**MUNICIPAL PLANNING COMMISSION
REGULAR SESSION AGENDA
August 26, 2026, 6:00 pm
Red Bank Court Room
3117 Dayton Boulevard**

Planning Commission Regular Session 8-26-2026

Request: Design Review for 3415 and 3423 Dayton Boulevard

DESIGN REVIEW STANDARDS CHECKLIST: 3415 Dayton Boulevard (2026-08-10)

PROPOSED SITE PLAN

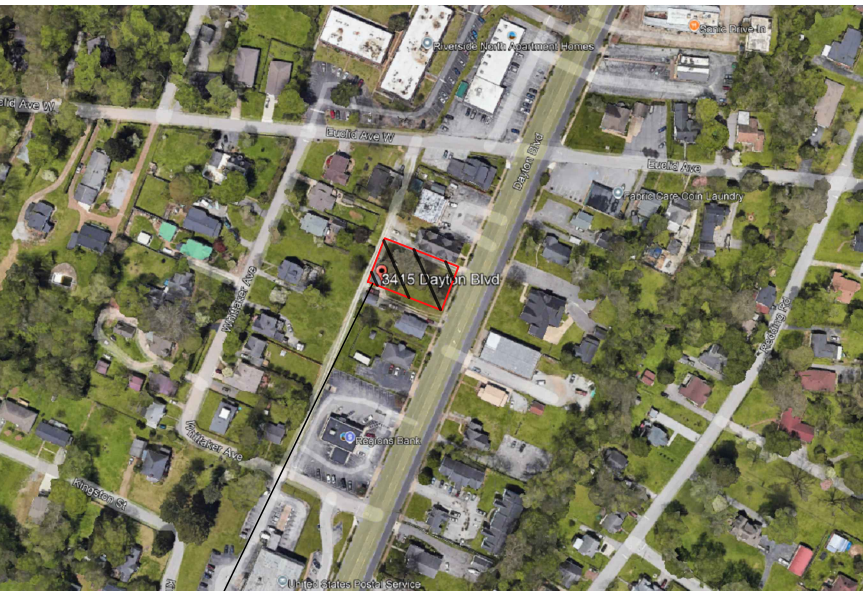
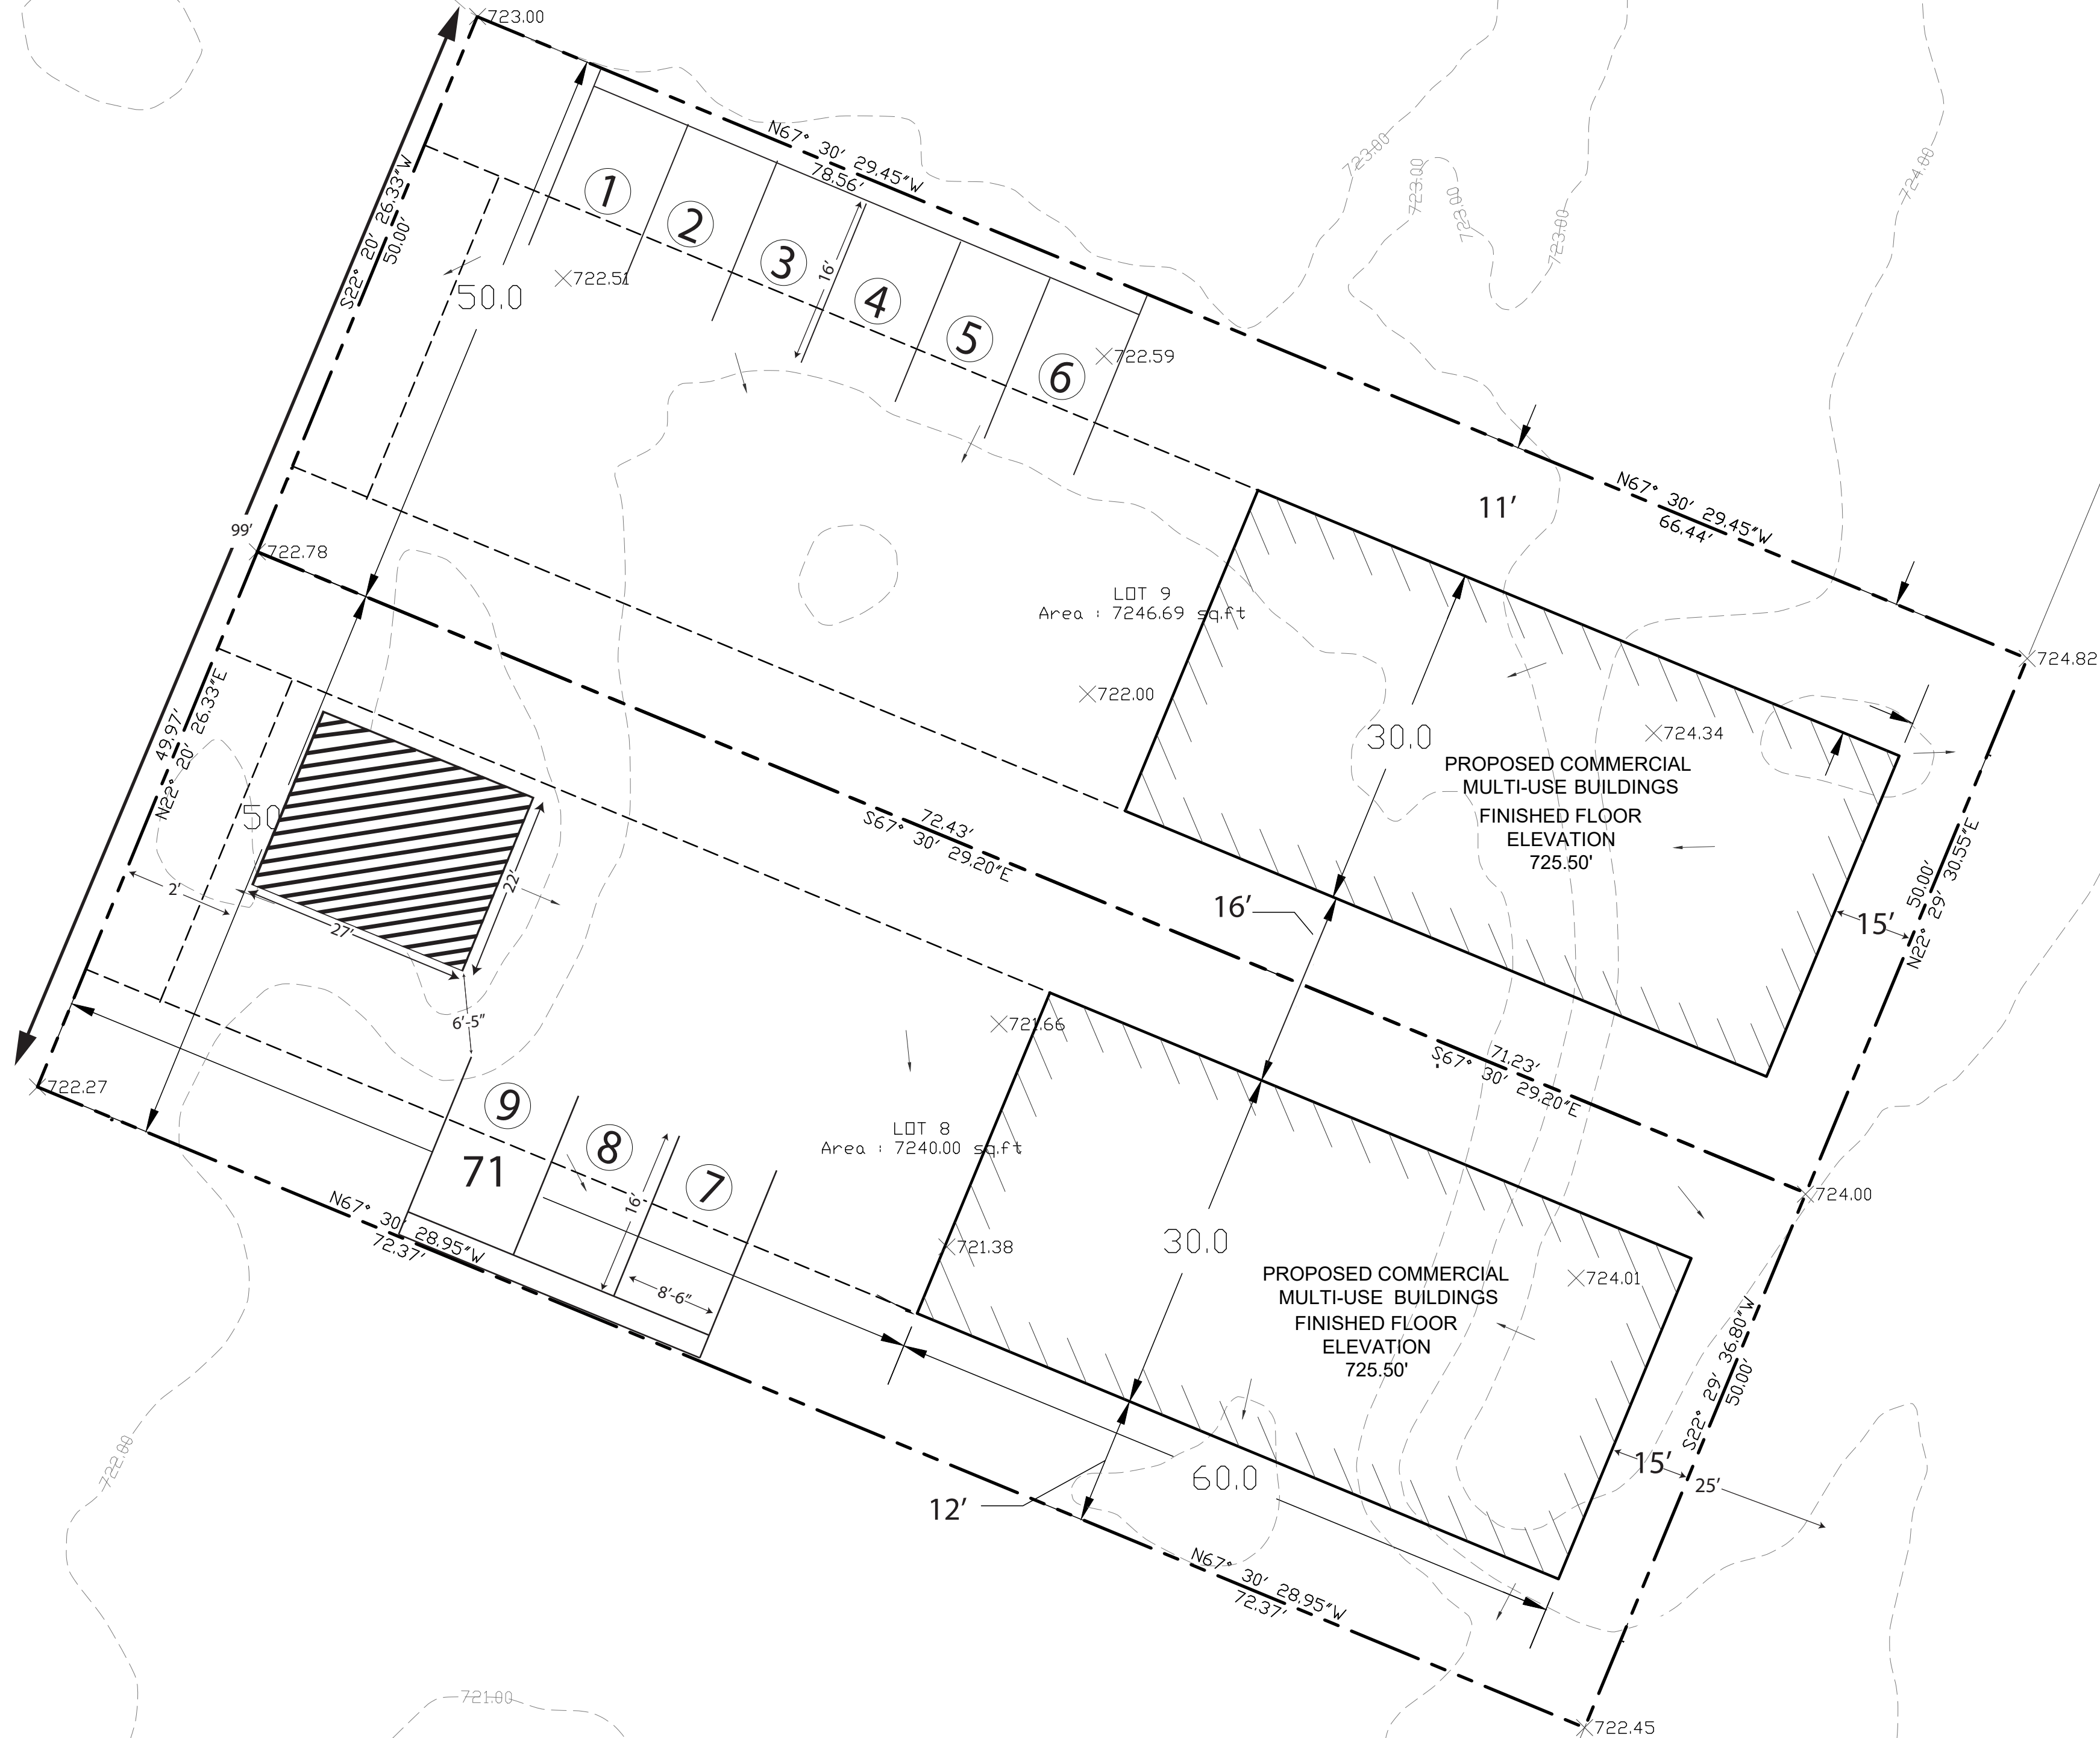
- o ***Building is setback 15' from the sidewalk but does not provide an 8' storefront area.***
- Mechanical equipment located on roof tops shall be screened from the public right-of-way.

Element	Exceptions and Notes	Design Standard	Description	Y/N
Setback and Orientation	Exceptions to setback requirements in the Building Zone can be made under the following circumstances: a. Exceptions due to steep slopes or other challenging physical site characteristics b. A specific design due to the style or development type approved by the Planning Commission or City Manager that meets the intent, objectives and	New buildings must be setback minimum of seven (7) feet and a maximum of twenty-five (25) feet from the public right-of-way of any street.	15' front setback	yes
		New buildings must be setback zero (0) feet from the back of the sidewalk , unless a Storefront area with a maximum width of eight (8) feet is provided between the Sidewalk and the Building Zone.	15' setback; no proposed storefront area but building exceeds 8' width permitted between sidewalk and building	no

- o ***The planning commission may defer the item and request a more specific landscaping plan to account for the removed trees, or grant a variance to the standard***

Summary Table

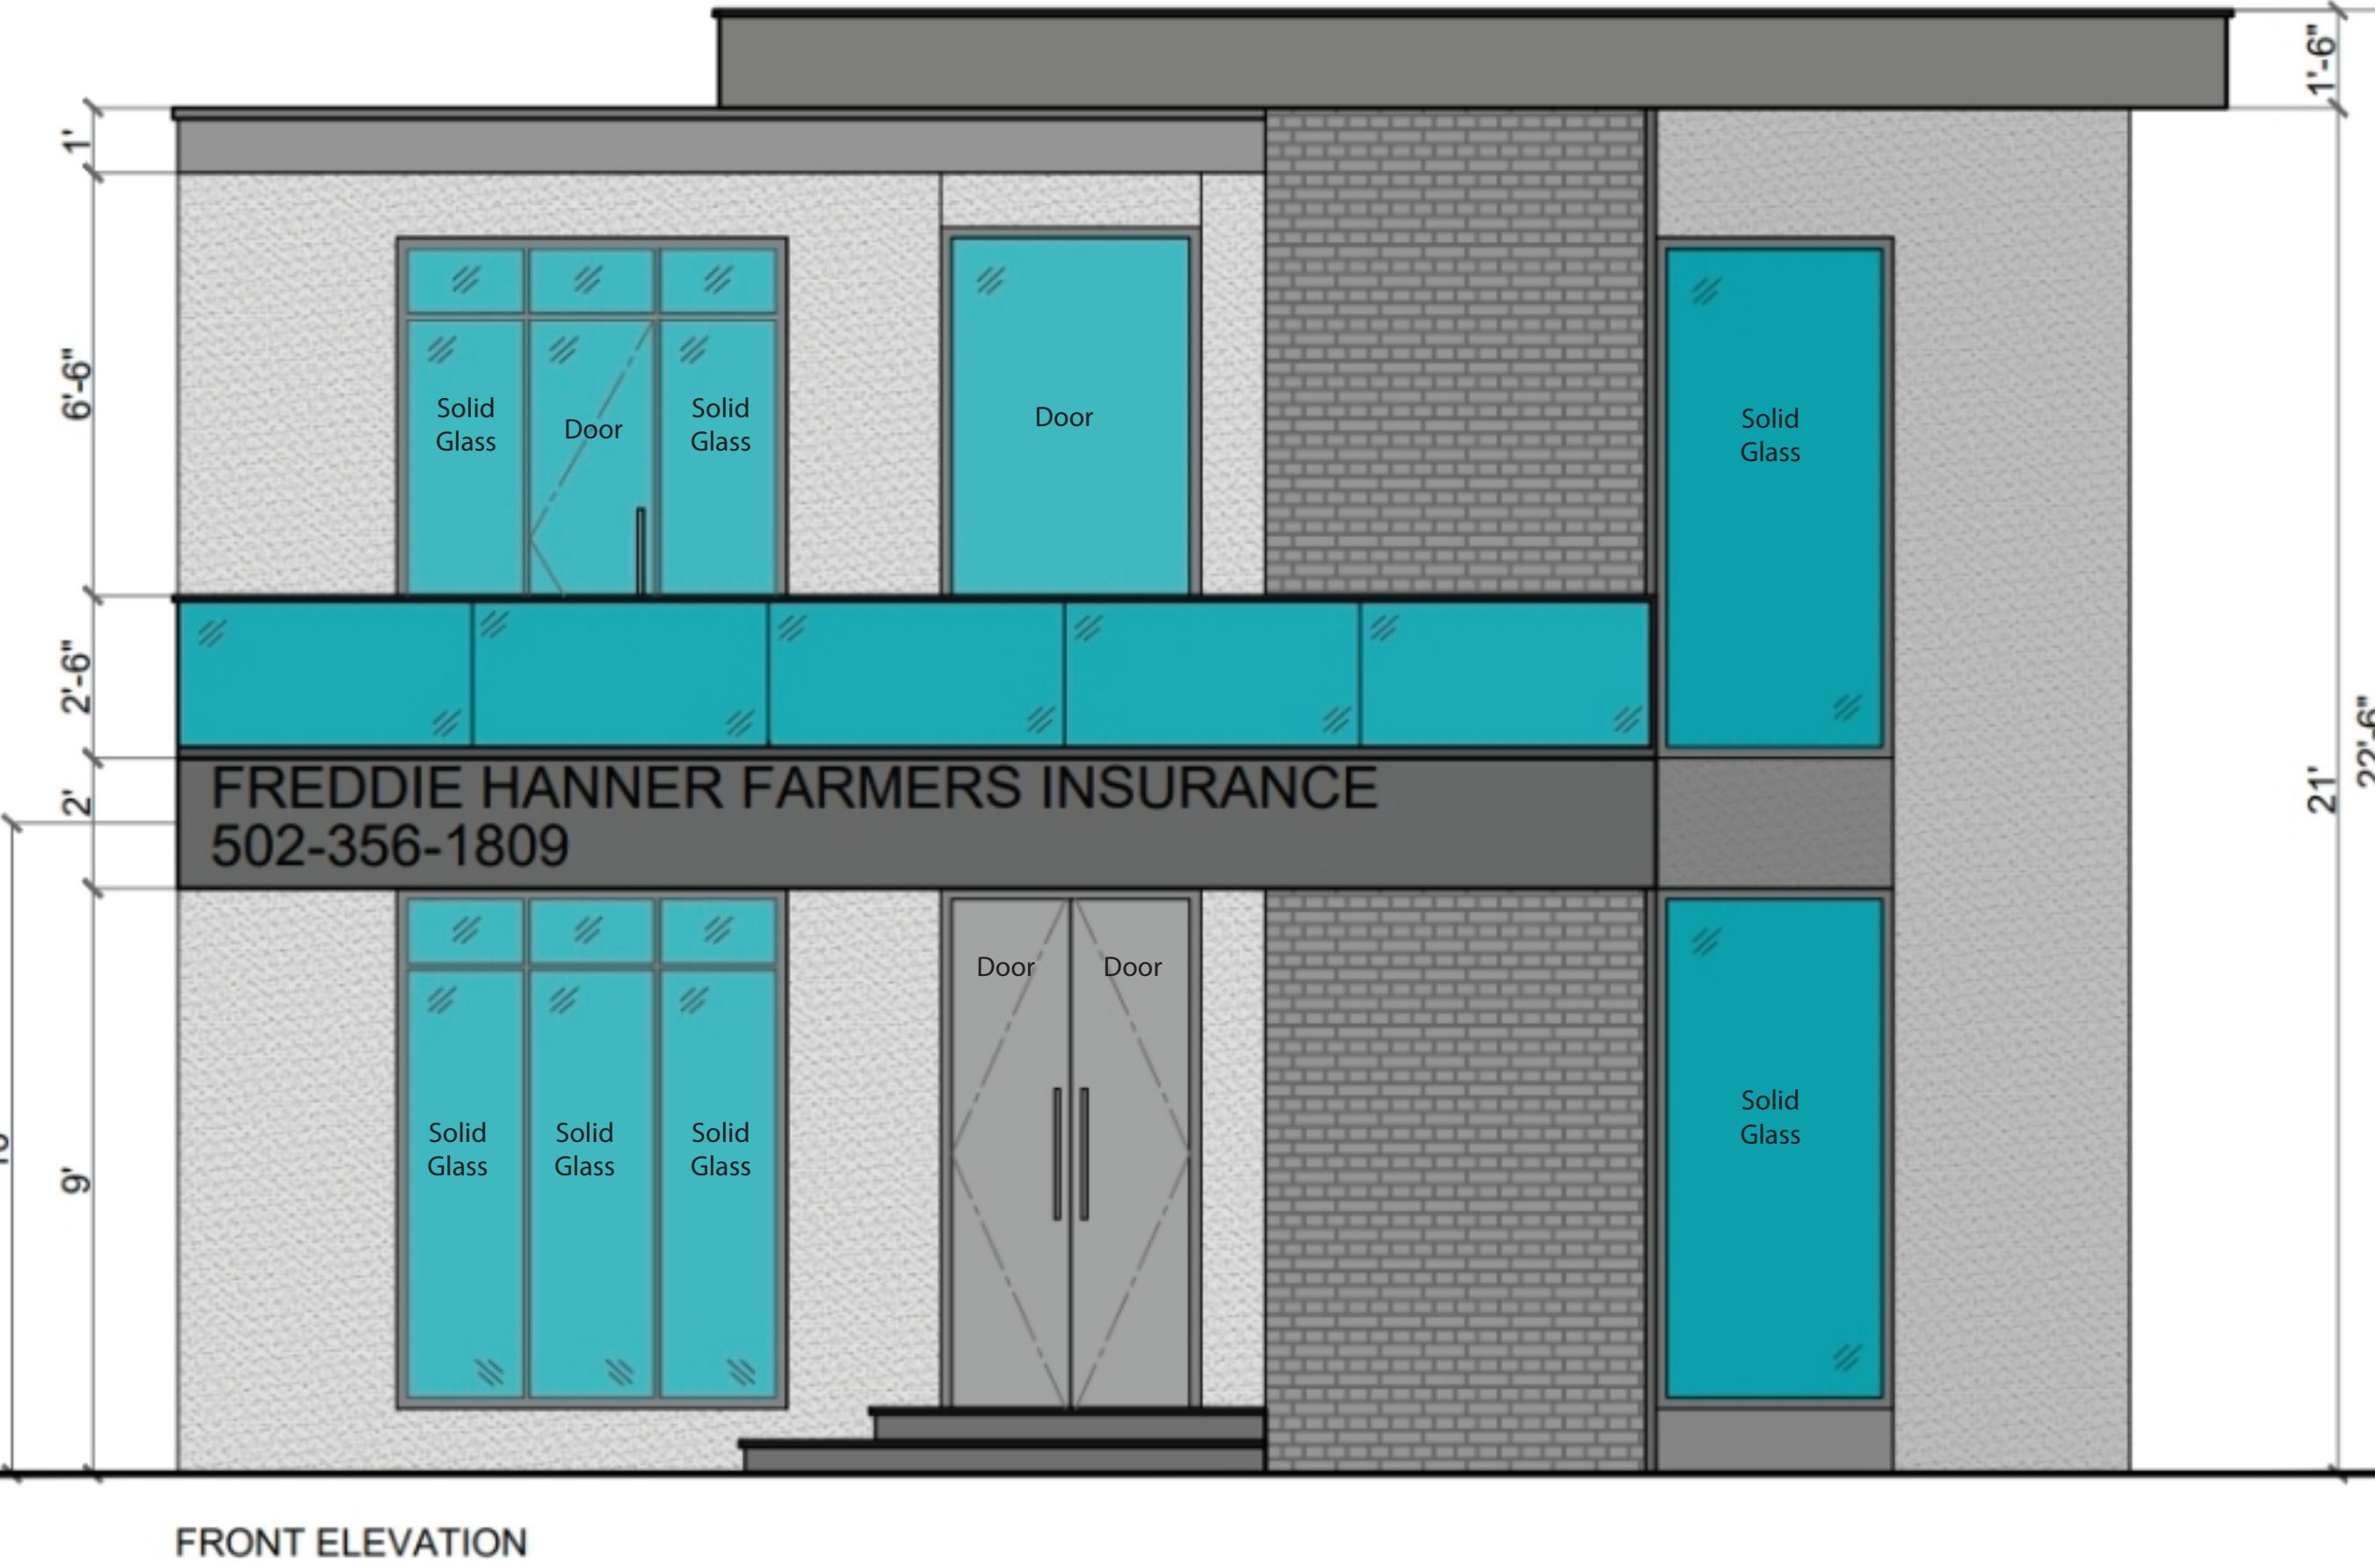
Element	Exceptions and Notes	Design Standard	Description	Y/N
		No single approved material (excluding glass) shall exceed seventy (70%) percent of the exterior building wall(s) that is visible from a public right- of-way and shall be comprised from the following alternative materials: factory-primed fiber-cement lap siding, glass, brick, stone, hard coat stucco, pre-cast concrete, architectural metal panels, and faux stone, and other materials as approved.	Sheet A-06 lists brick veneer, faux stone, primed fiber-cement as the exterior finish	no
		Does not contain prohibited materials visible from public right-of-way: flat metal or corrugated tin or zinc coated siding, vinyl (or similar) siding, and unpainted/untreated concrete block. Commercial zones only.	No prohibited materials proposed	yes
Façade Transparency	Specific alternative designs may be approved by the Planning Commission or City Manager. Tinted or reflecting glass is discouraged.	Retail Buildings: façades facing the public right-of-way shall have at least thirty percent (30%) of the façade area comprised of clear vision glass at the ground level	Calculations shown state glass windows doors and balcony railings are 35.7% of the facade	yes

KWPD Series - Wattage & CCT Selectable
LED Full Cutoff Wall Pack

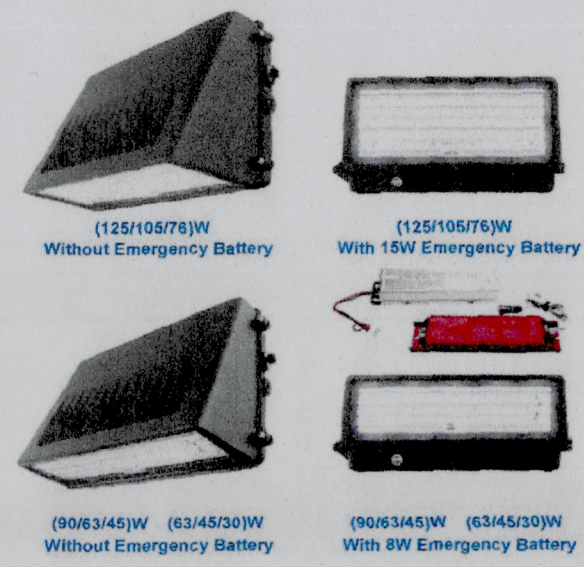
- o ***Ground level illumination not shown, but product cut sheet implies that minimum illumination is met.***
- Design standards and requirements that relate to trees, vegetation, terrain and waterways were not met.

Element	Exceptions and Notes	Design Standard	Description	Y/N
		Parking lot landscaping should incorporate best management practices (BMPs) for storm water and other green infrastructure into the design are encouraged to reduce storm water runoff and pollution. Applicants should refer to the Hamilton County Water Quality Manual for guidance on appropriate storm water BMPs for their site.		n/a
Parking Lot Lighting	Existing lighting structures, fixtures and bulbs are exempt from these standards.	All New lighting fixtures and bulbs shall be LED, shielded if necessary, equipped with refractors, or placed indirectly to prevent stray upward light or direct light causing glare.	A-08 shows nine(9) wall mounted exterior lights; applicant included a scan of a product sheet for a light that meets the standards	No
	Special interest and accent lightings are encouraged to be integrated with landscaping and streetscape features.	New pedestrian-scale lighting should be provided on the walkways, parking lots and open spaces consistent with the character of the development.	A-08 shows nine(9) wall mounted exterior lights; applicant included a scan of a product sheet for a light that meets the standards	No
